**Marion County
Board of County Commissioners**

SUBJECT: INITIAL COMMENTS LETTER
PROJECT NAME: EL FARO DUPLEXES
PROJECT #2025080063
APPLICATION: MAJOR SITE PLAN #33316

DEVELOPMENT REVIEW COMMITTEE WAIVER REQUEST FORM

MICHAEL W. RADCLIFFE ENGINEERING, INC.	
Project No.	AR-33316
Sheet No.	C009
Scale	1" = 50'
Date	09-05-25
Drawn	MM
Checked	MM
Approved	MM
www.radcliffeengineering.com	
Existing Conditions	
Sheet No.	C009
of	C009

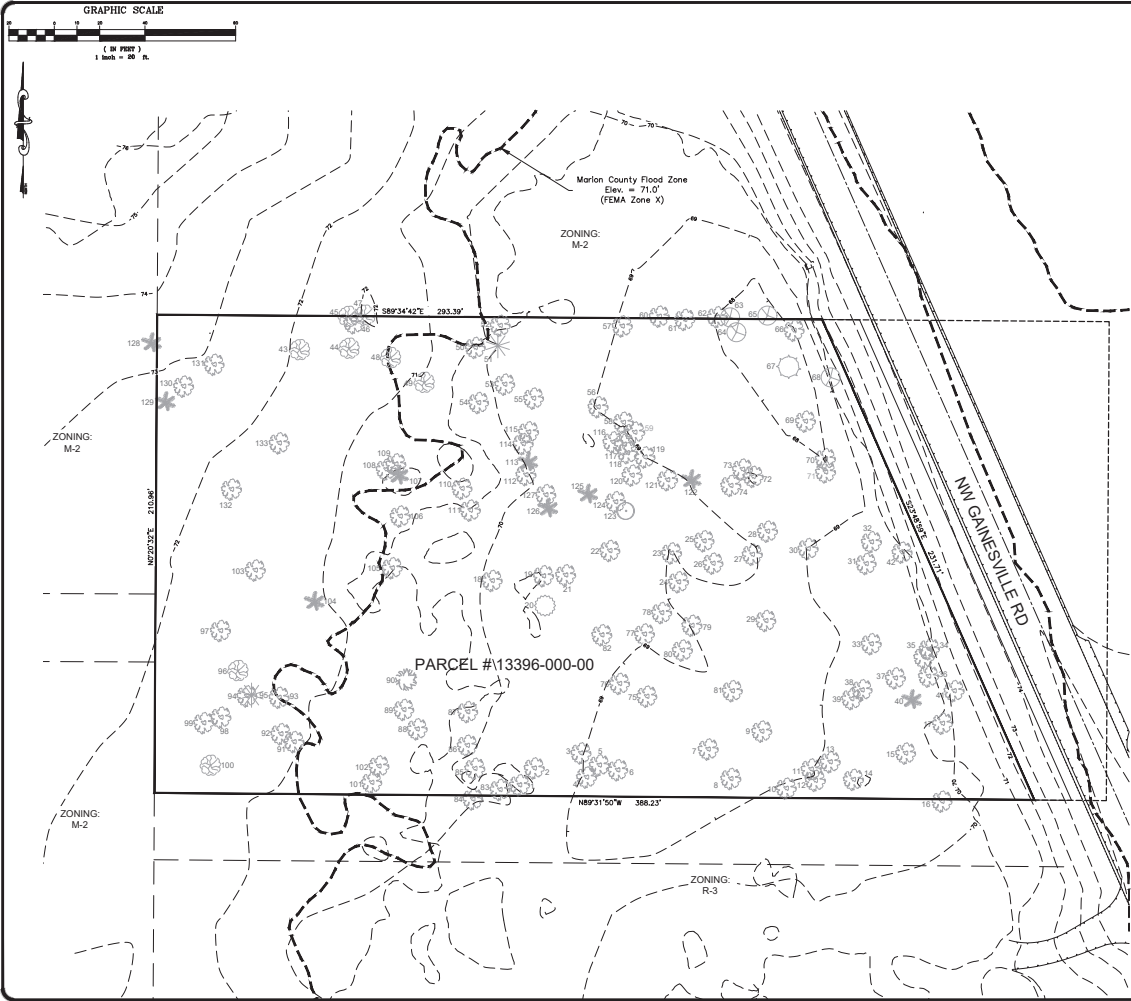
REMARKS: 9/12/25 C009 - Remove Marion County Utilities from the Utility Contact list.

REMARKS: 1. Several trees shown to remain may have the critical root zone impacted by construction activities, how will roots be protected? (10, 1,2 83,101, 97, 108,109, 120,124, 42, etc...) 2. Existing trees shall not be with 20' of the proposed buildings, please confirm, and show dimension line. Tree # 97 will be to close to the building, shall not be within 20'. 3. All invasive species to be removed from site, legend shows several Camphors to remain
